Access Compliance Report

Public Rights-of-Way

(Curb Ramps)

Intersection ID: 5654	Main Street: JOHN_KIRK_DR	Cross Street: JOHN_KIRK_DR	Location: NE
ADA ID: 8517CE853280	Ramp Type: BlendTrans1	Initial Pass/Fail: Pass	Overall Compliance: No
Severity Score: 7.75			
Codes/Mitigation Info/Possible Solution		Field Measurements/Component Compliance

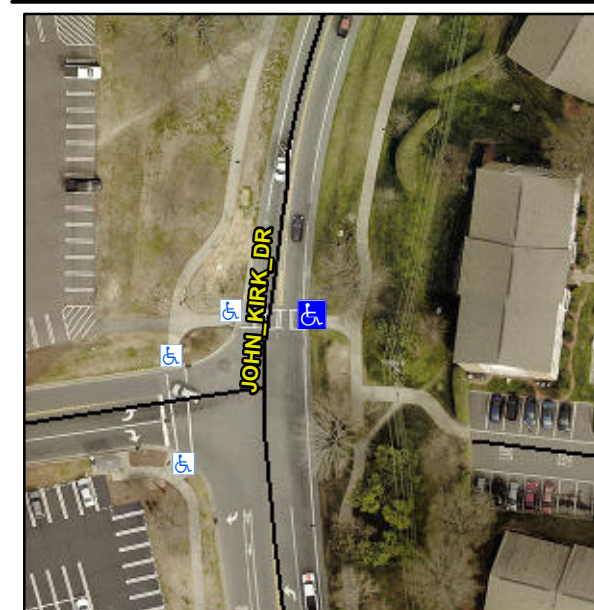
R304.2.2-Perp, R304.3.2-Para, R305.1.4, R304.5.4, R304.5.3

Compliance	Description	Data	Compliance	Description	Data
N/A	Ramp Length (in)	117.0	Yes	BlendTrans Slope (%)	1.3
Yes	Ramp Width (in)	72.0	Yes	BlendTrans XSlope (%)	3.3
N/A	Flare Type LT	None	N/A	Flare Type RT	None
N/A	Flare Slope LT (%)	N/A	N/A	Flare Slope RT (%)	N/A
N/A	Flare Traversable LT?	N/A	N/A	Flare Traversable RT?	N/A
Yes	Landing Length (in)	63.0	Yes	DWS Provided?	Yes
Yes	Landing Width (in)	72.0	Yes	DWS Contrast?	Yes
No	Landing Slope (%)	2.8	Yes	DWS Length (in)	25.0
Yes	Landing X Slope (%)	3.8	No	DWS Full Width?	No
N/A	Landing Curb? (Y/N)	No	Yes	DWS Offset (in)	0.0
N/A	Shared Landing?	No			
Yes	Gutter Ponding?	No	No	Gutter Slope (%)	6.1
Yes	Gutter Lip Ht (in)	0.0	No	Gutter X Slope (%)	3.9
N/A	Painted X Walk1?	Yes	N/A	Painted X Walk2?	N/A
	X Walk 1 Direction	To NW		X Walk 2 Direction	N/A
	X Walk 1 Width (in)	110.0		X Walk 2 Width (in)	N/A
	X Walk 1 Slope (%)	1.9		X Walk 2 Slope (%)	N/A
	X Walk 1 X Slope (%)	3.8		X Walk 2 X Slope (%)	N/A

Yes	Ramp inside XWalk1?	Yes	N/A	Ramp inside XWalk2?	N/A
	Road Slope (%)	3.8		Clear Space?	Yes
	Road X Slope (%)	1.9	N/A	Clear Space to XWalk (in)	N/A
Yes	Any Obstructions?	No	Yes	Storm Grate/Utility Hazard?	No
	Obstruction Type			Storm Grate/Utility Type	
			N/A		N/A
			Yes	Surface Condition? (G/P)	Good
			Yes	Curb Slope (%)	3.8

Remove & Replace Curb Ramp With Two New Directional Ramps or Equivalent. Remove & Replace Gutter.
